Cc: Subject: George Marek; Larry Raether; Norman, Michele R - DNR RE: Request to Retract Off-Site Notification Letters - Former Midwest Tanning Corp.,

South Milwaukee, WI. BRRTS #: 02-41-556117

LOCATION OF SB-15 AND MW-5

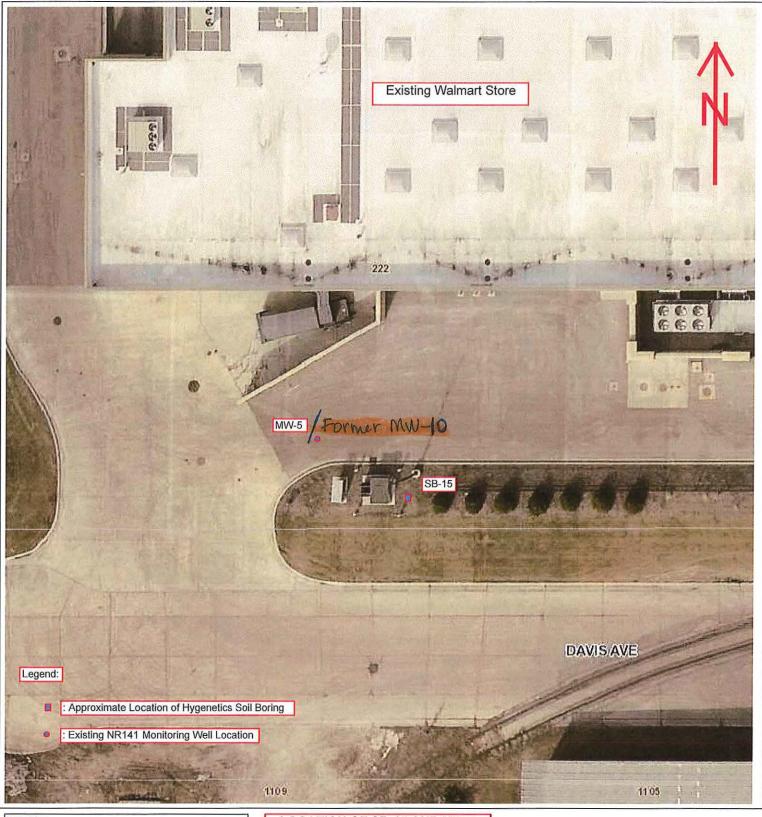
I have attached a diagram that shows the location of the existing NR141 monitoring well MW-5 and the approximate location of the Hygienetics soil boring SB-15. It appears that the soil boring location is about 30 feet to the southeast of the well location. Is the well close enough to the location of the soil boring? Let us know when you have a chance.

Attached are two figures showing the relative locations of the existing monitoring MW-5 (i.e. Former MW-10) and the Hygienetics soil boring SB-15. The well is not close enough to the location of the soil boring. Please let us know if you have questions. Thanks.
